5928-07-20246
December 28, 2007

Three Mile Island Nuclear Station, Unit 1
Facility Operating License No. DPR-50
NRC Docket No. 50-289

Subject: Three Mile Island Unit 1 Supplemental Response to NRC Generic Letter 2004-02, "Potential Impact of Debris Blockage on Emergency Recirculation during Design Basis Accidents at Pressurized-Water Reactors"

Attachment 1 Three Mile Island Unit 1, Supplemental Response to USNRC Generic Letter
2004-02

Figure 2. CSHL Flow Path at TMI Unit 1.

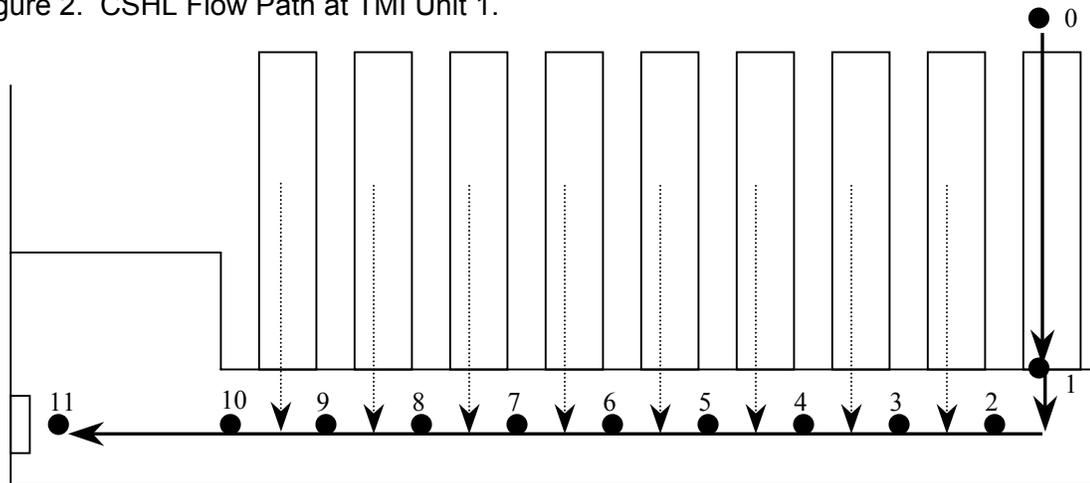
- 9. Provide a summary of the methodology, assumptions, bases for the assumptions, and results for the clean strainer head loss calculation.*
- 10. Provide a summary of the methodology, assumptions, bases for the assumptions, and results for the debris head loss analysis.*

5. Nodes 2 through 10 are modeled as converging wye intersections with each row of top hats entering the channel from the branch.
6. Finally, Nodes 10 to 11 are modeled as a sudden expansion into the collector box.

7. The top hat, channel, and collector box head losses are summed to produce the total clean strainer head loss.

Figure 3. Schematic of the TMI Unit 1 Reactor Building Sump

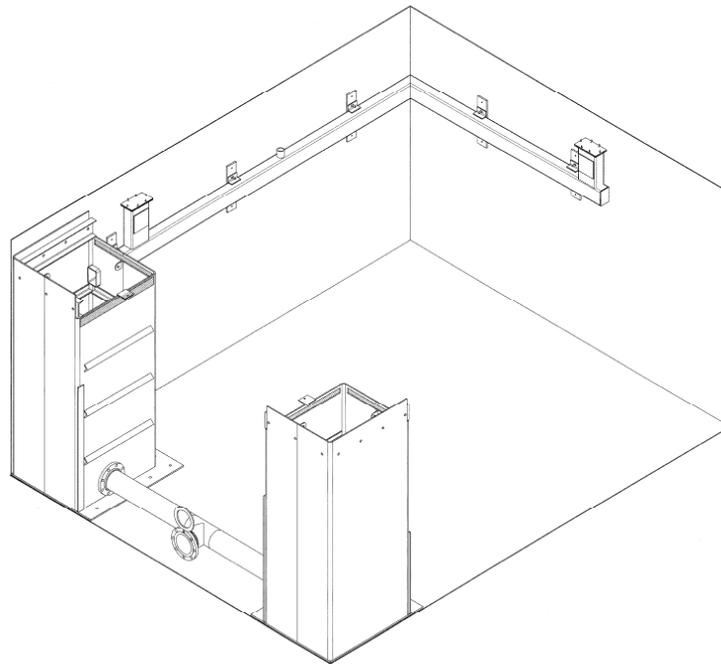
- 1. Provide a description of the major features of the sump screen design modification.*
- 2. Provide a list of any modifications, such as reroute of piping and other components, relocation of supports, addition of whip restraints and missile shields, etc., necessitated by the sump strainer modifications.*

The sump was divided into a normal “wet” sump and an ECCS “dry” sump. The new normal sump design is two (2) boxes that are approximately 3 ft x 2.5 ft in plan and 6 ft in height located in the corners at the west end of the existing sump pit on either side of the ECCS suction pipes.

Figure 6. NRC Chemical Effects Evaluation Process Flow Diagram

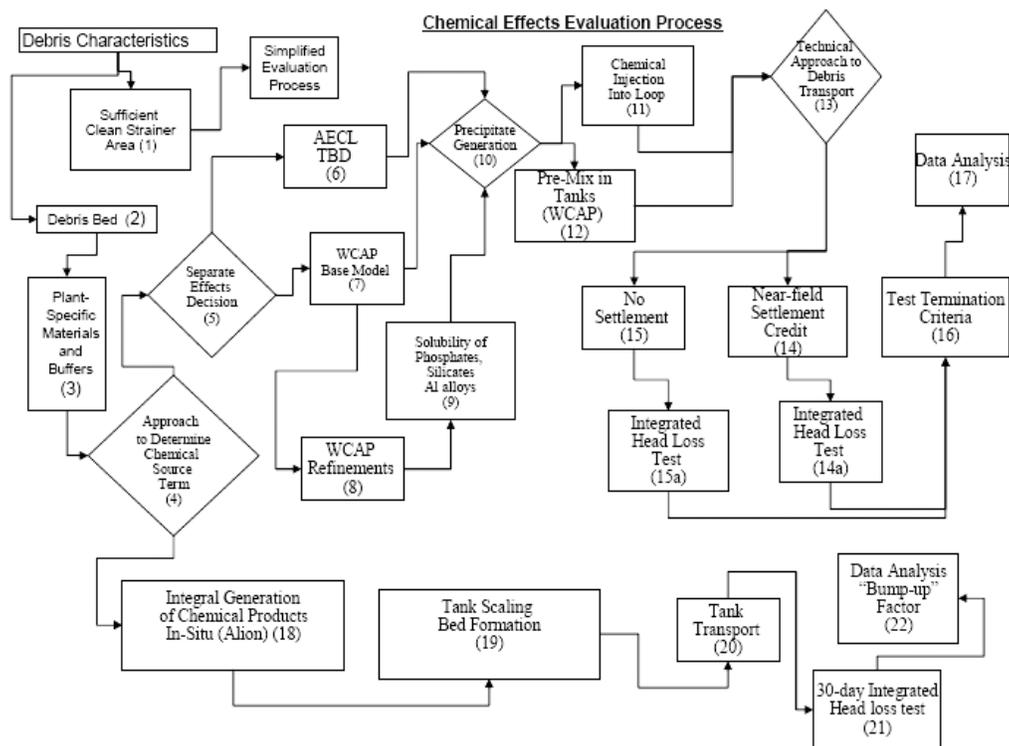
- ii. *Licensees should provide the chemical identities and amounts of predicted plant-specific precipitates.*
- 2.7 *WCAP Base Model*
 - i. *For licensees proceeding from block 7 to diamond 10 in the Figure 1 flow chart [in Enclosure 3 to a letter from the NRC to NEI dated September 27, 2007 (ADAMS Accession No. ML0726007425)], justify any deviations from the WCAP base model spreadsheet (i.e., any plant specific refinements) and describe how any exceptions to the base model spreadsheet affected the amount of chemical precipitate predicted.*

TMI Unit 1 does not proceed from block 6 to diamond 10 in the Figure 1 flow chart detailed in Enclosure 3 of Reference 4, shown below as Figure 6, as WCAP refinements (block 8) are utilized on aluminum oxy-hydroxide components, as noted in the response to question 2.o.2.8.i.
